CITY OF RAMSEY LAND USE APPLICATION
TECHNICAL REVIEW FILE

DATE	DECEMBER 13, 2017 REVISED: JANUARY 25, 2018	PROJECT ADDRESS	TBD
PROJECT TITLE	AFFINITY AT RAMSEY		
ESCROW #	116093		
DEPARTMENT:	Community Development: Planning Division (Landscape Plan & Environmental Resources)		
TECHNICAL REVIEWER:	Name: Chris Anderson, City Planner Phone: 763-433-9817 Email: canderson@cityoframsey.com

DATE	JANUARY 25, 2018	PROJECT ADDRESS	CORNER OF CENTER STREET NW AND 146 TH AVENUE NW
PROJECT. TITLE	PRELIMINARY PLAT AND SITE PLAN REVIEW		
ESCROW #	116093		
DEPARTMENT:	Community Development: Planning Division (Zoning Code)		
TECHNICAL REVIEWER:	Name: Eric Maass, Consultant Planner Phone: 763-576-4306 Email: EMaass@wsbeng.com

Preliminary Plat and Site Plan Review

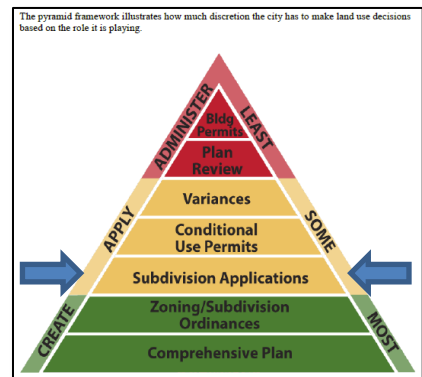
Land Use and Zoning. The Property is guided as Mixed Use in the Comprehensive Plan and is zoned The COR. The intent of the Mixed Use land use designation is to allow for the construction of a variety of uses including retail, commercial, entertainment, office, institutional, high density residential, transit hubs and park and recreation uses with access to municipal sewer and water. The proposed use is consistent with this land use guidance. The project is located within the COR 1 Mixed Use Core. This subdistrict is intended to be the most urban of all sub-districts in The COR. The compact and higher density blocks that define this subdistrict encourage a mix of uses, with a continuous built edge along street frontage. Innovative parking strategies support this mix, providing easy access to destination shopping, restaurant and entertainment venues. This district requires a minimum density of 15 units per acre. As proposed, the density achieved would be 51.2 units per acre.

Lot Dimensions. There is no minimum lot size in The COR 1 Mixed Use Core subdistrict. The minimum lot width is 20 feet, measured at the building setback line, and the minimum lot depth is 80 feet. The proposed lot is 3.38 acres in size and the proposed outlots are 3.90 acres and 9.38 acres in size.

Setbacks and Dimensional Standards.
